**Reference** 25/1820/FUL

**Proposal** Proposal to demolish existing public toilets and replace with a new modular public toilet building. (Retrospective application for design changes to approved application 23/2561/FUL)

### RECOMMENDATION: Approval with conditions

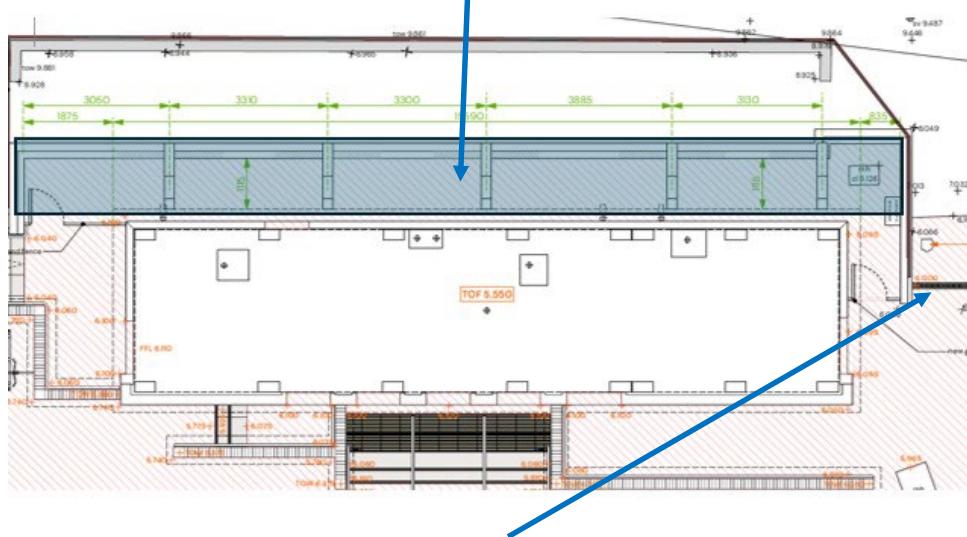
- Unauthorised access to the rear of the site should be prevented as surveillance opportunities are limited and a concealed area such as this is likely to attract antisocial behaviour if accessible. Security fencing should meet a nationally recognised security standard such as LPS1175.
- Apologies but what is the intended use of this space and the room accessible via the rear door? Presumably it is for maintenance access only and not public access? Therefore, the gates at either end should be of the same standard as the fencing, being mindful that any emergency egress mechanism can not be accessed from the public side

Additionally, ensure there are no climbing aids such as low-level walls etc. that can be used to overcome gates / fencing. I am unsure if this is a proposed low-level wall?
